Access Compliance Report

Public Rights-of-Way

Intersection ID: 45180	Main Street: SOCIETY_ST	Cross Street: TORRELLE_DR	Location: NE
ADA ID: B07B4670C4AF	Ramp Type: PerpDiag	Initial Pass/Fail: Fail	Overall Compliance: No
Codes/Mitigation Info/Possible Solution		Field Measurements/Component Compliance

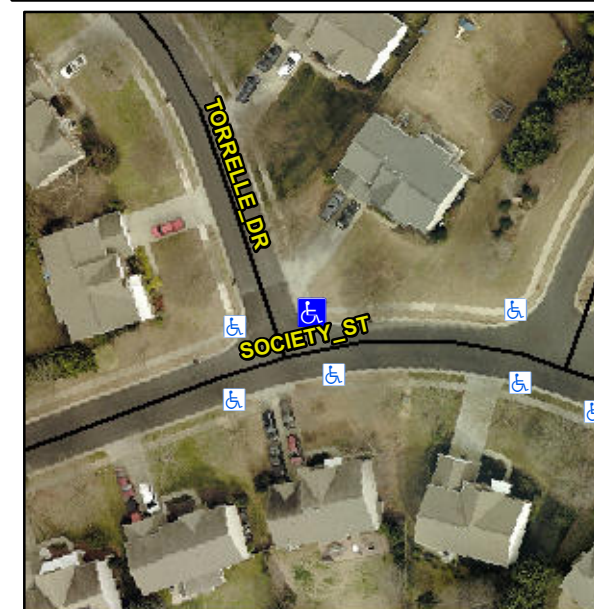
Not Found, R304.5.1, R304.5.3

Compliance	Description	Data	Compliance	Description	Data
N/A	Ramp Length (in)	92.0	Yes	Ramp Slope (%)	5.2
No	Ramp Width (in)	47.5	No	Ramp XSlope (%)	5.2
N/A	Flare Type LT	N/A	N/A	Flare Type RT	N/A
N/A	Flare Slope LT (%)	N/A	N/A	Flare Slope RT (%)	N/A
N/A	Flare Traversable LT?	N/A	N/A	Flare Traversable RT?	N/A
N/A	Landing Length (in)	N/A	N/A	DWS Provided?	N/A
N/A	Landing Width (in)	N/A	N/A	DWS Contrast?	N/A
N/A	Landing Slope (%)	N/A	N/A	DWS Length (in)	N/A
N/A	Landing X Slope (%)	N/A	N/A	DWS Full Width?	N/A
N/A	Landing Curb? (Y/N)	N/A	N/A	DWS Offset (in)	N/A
N/A	Shared Landing?	N/A			
N/A	Gutter Ponding?	N/A	N/A	Gutter Slope (%)	N/A
N/A	Gutter Lip Ht (in)	N/A	N/A	Gutter X Slope (%)	N/A
N/A	Painted X Walk1?	No	N/A	Painted X Walk2?	No
	X Walk 1 Direction	To W		X Walk 2 Direction	To S
N/A	X Walk 1 Width (in)	N/A	N/A	X Walk 2 Width (in)	N/A
	X Walk 1 Slope (%)	0.5		X Walk 2 Slope (%)	0.9
	X Walk 1 X Slope (%)	0.9		X Walk 2 X Slope (%)	0.8

Remove & Replace Curb Ramp With Two New Directional Ramps or Equivalent.
